RE: Request to amend Exhibit "F" Design Standards for Building A3-Theatre for the Shops at Broad PD ZC #16-008 Planned Development.

FLIX BREWHOUSE - EXTERIOR CONCEPT

MANSFIELD, TX
26 MARCH 2019

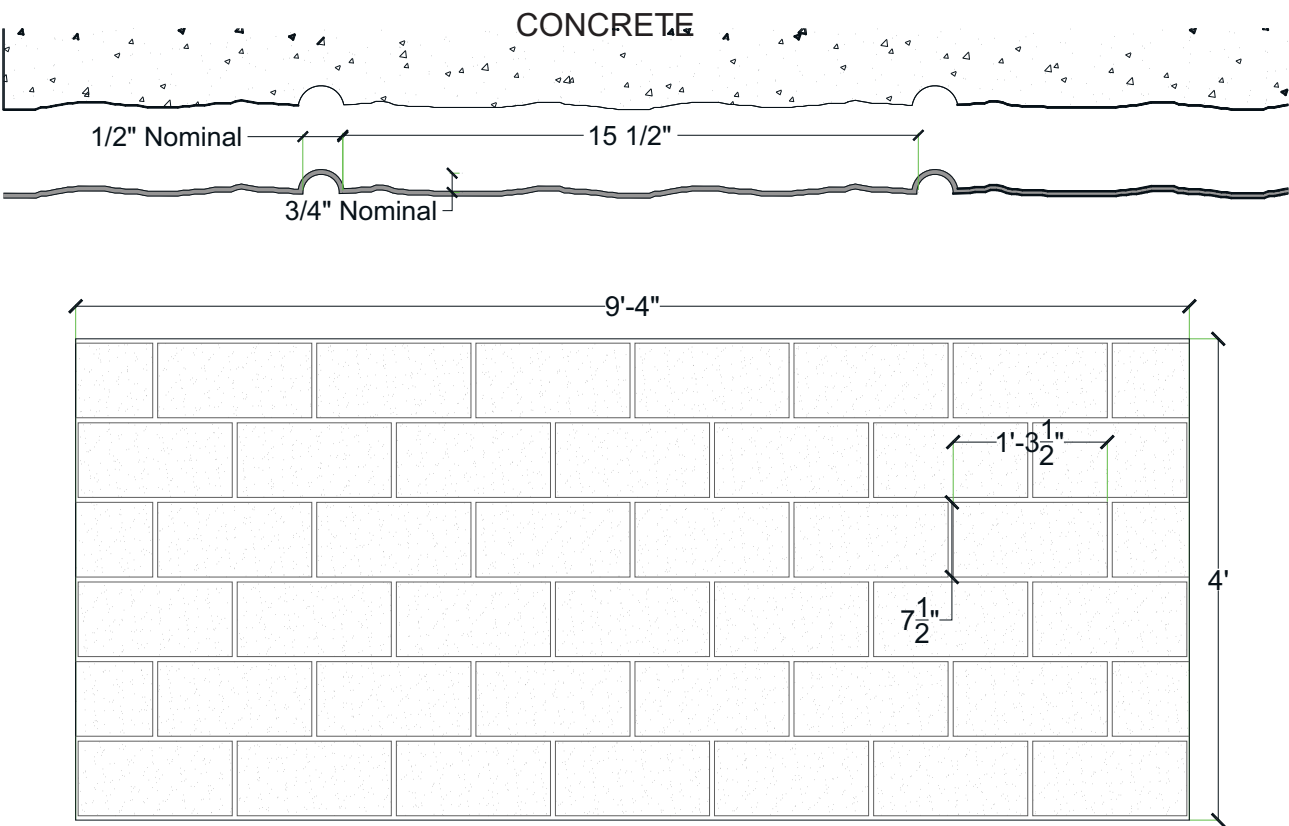
We are submitting this request to amend the exterior wall requirements described in the Design Standards referenced above to include cast in place concrete exterior wall construction with the use of Formliners.

Formliners are typically used to cast a simulated look of masonry into the exterior concrete walls during fabrication. Attached is the product data sheet we are proposing to use that described the pattern and texture the exterior walls will be prepared to simulate concrete masonry units (CMU). The exterior walls will be reviewed after the Formliners are removed and prior to erection for any imperfections to ensure the quality of the pattern and texture are maintained. Then a colored coating will be applied to represent the design pattern and colors shown on the renderings that have been included in this proposal.

1. C1 - CONCRETE TILT-UP PANEL - FORMLINER PATTERN TO MATCH 8"X16" CMU - PAINT COLOR TO MATCH SHERWIN WILLIAMS SW7052 GRAY AREA
2. C2 - CONCRETE TILT-UP PANEL - FORMLINER PATTERN TO MATCH 8"X16" CMU - PAINT COLOR TO MATCH SHERWIN WILLIAMS SW7050 USEFUL GRAY
